During the issuance of Amendment No. 42, dated July 6, 1979, to Provisional Operating License No. DPR-13 for the San Onofre Nuclear Generating Station Unit 1, we inadvertently changed the Appendix B Technical Specification (ETS) 5.3.2.a, membership of the Nuclear Audit and Review Committee (page 5-5), instead of ETS 5.3.1.a, membership of the Onsite Review Committee (page 5-1). In addition, Figures 6.2.1.1 and 5.2-1, which were approved by Amendment No. 42, were unintentionally omitted. The enclosed pages correct these editorial and administrative errors.

ATTACHMENT TO LICENSE AMENDMENT NO. 42

PROVISIONAL OPERATING LICENSE NO. DPR-13

DOCKET NO. 50-206

FIGURE 6.2.1.1  
OFFSITE ORGANIZATION

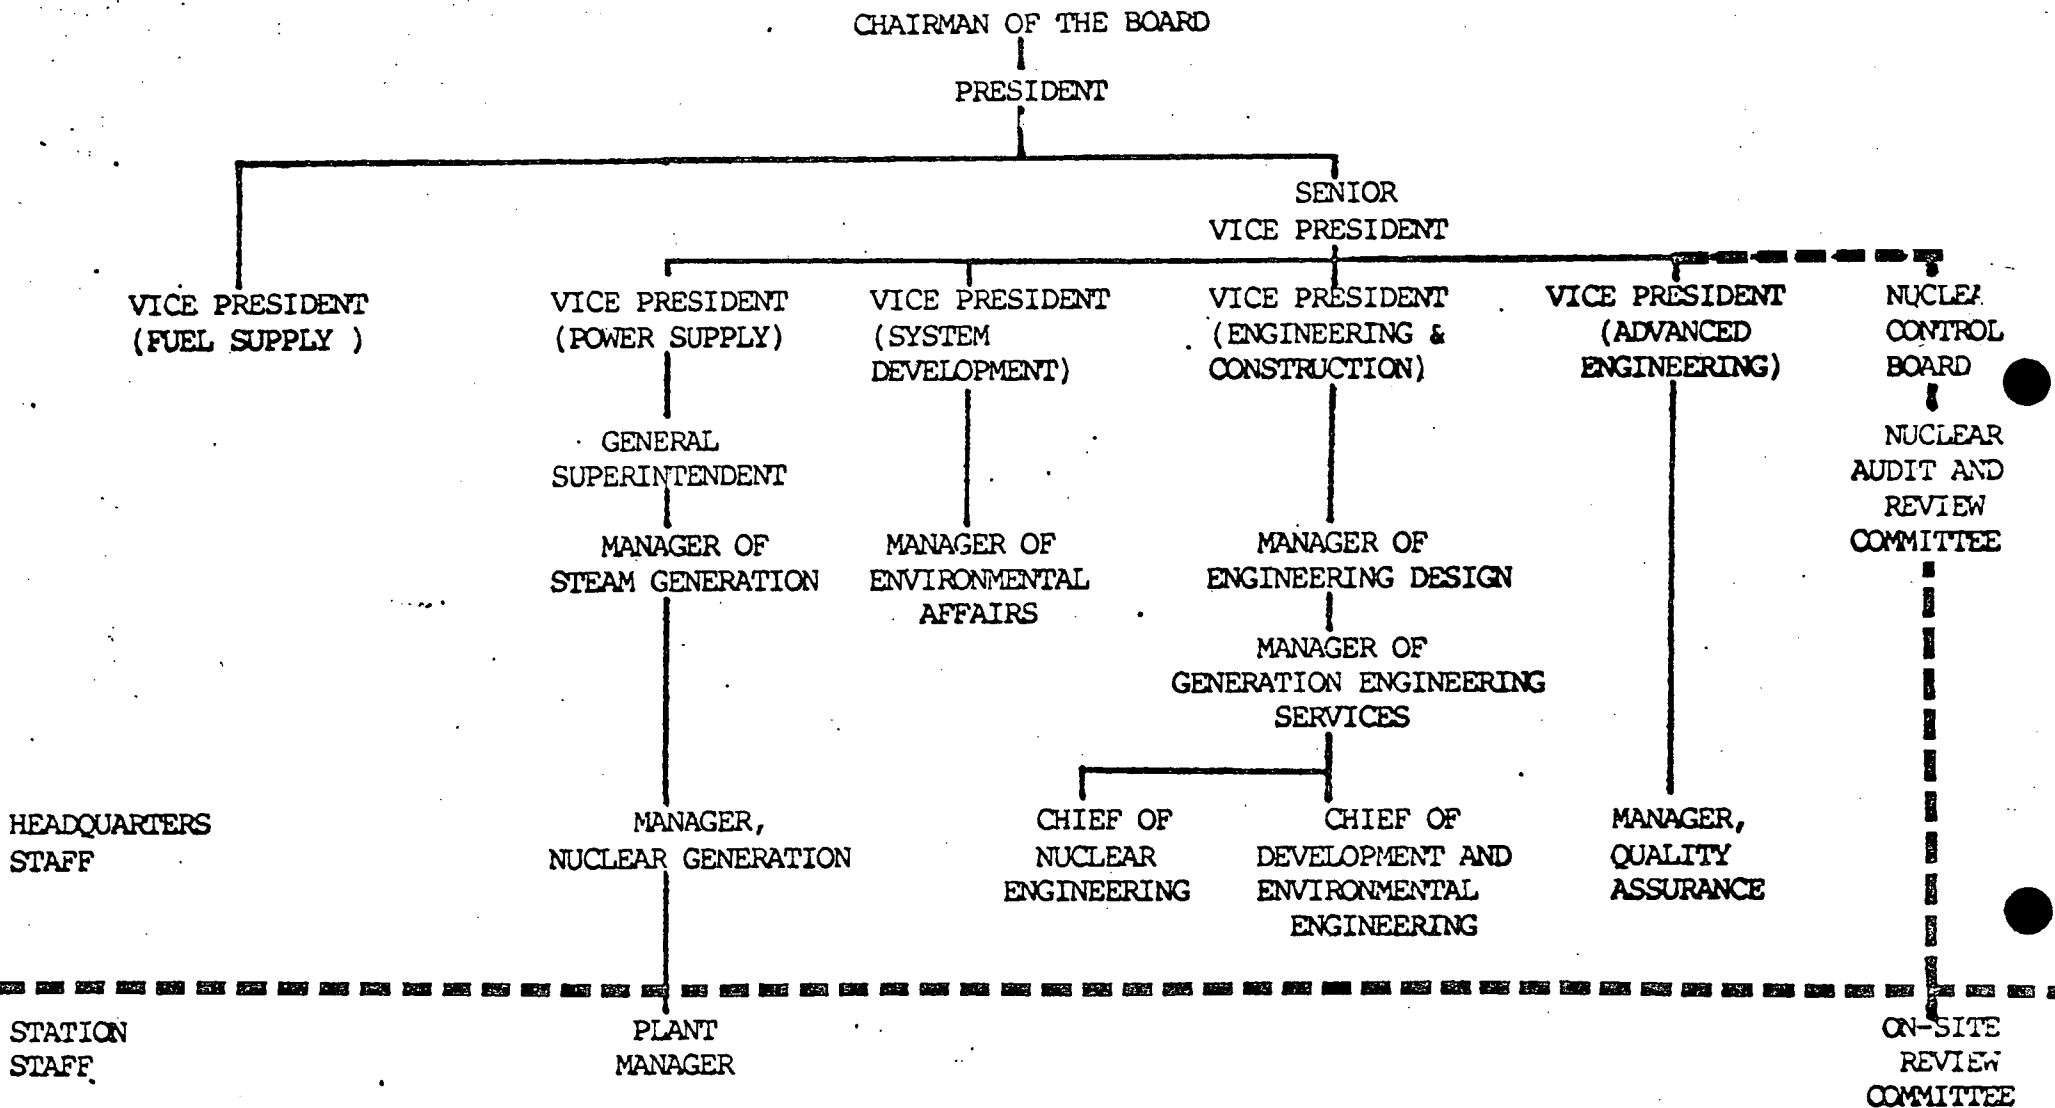
(Correction)

FIGURE 5.2-1 SOUTHERN CALIFORNIA EDISON COMPANY CORPORATE ORGANIZATION

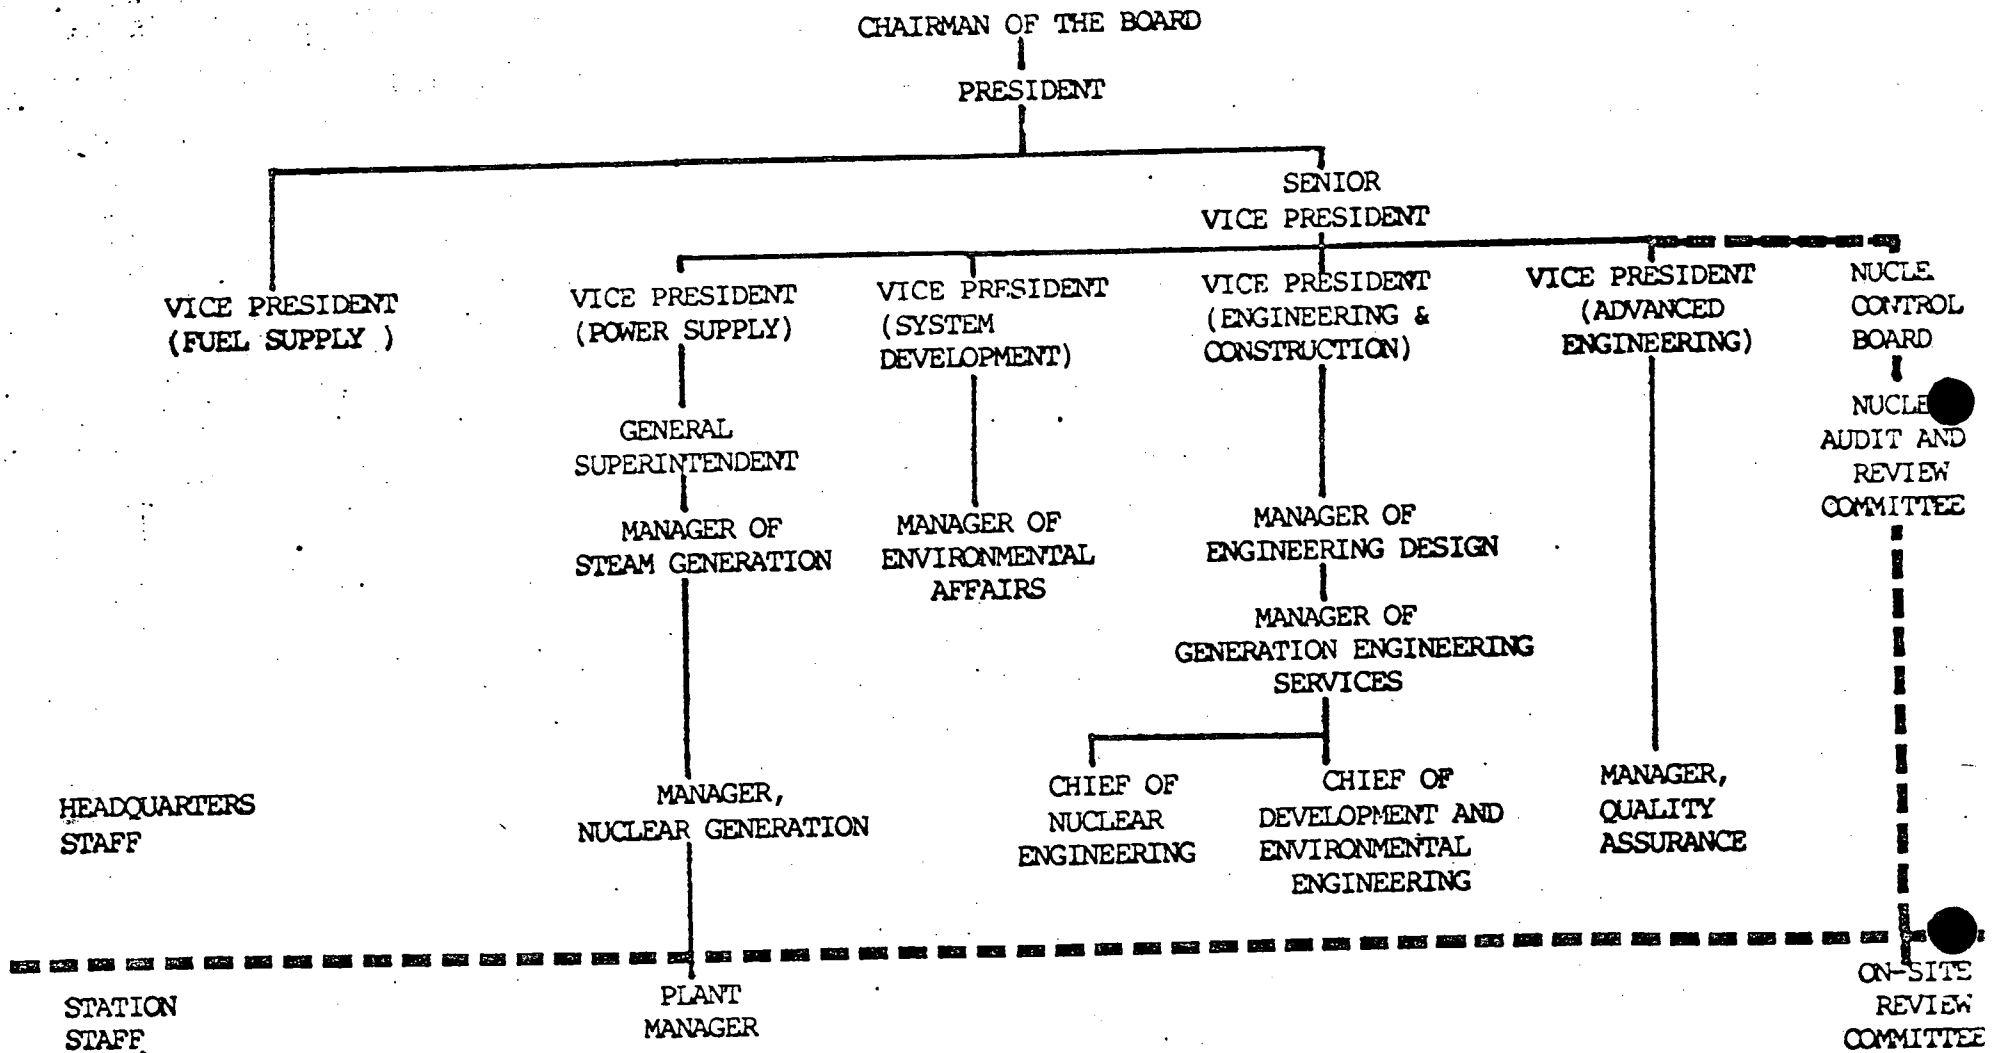
(Correction)
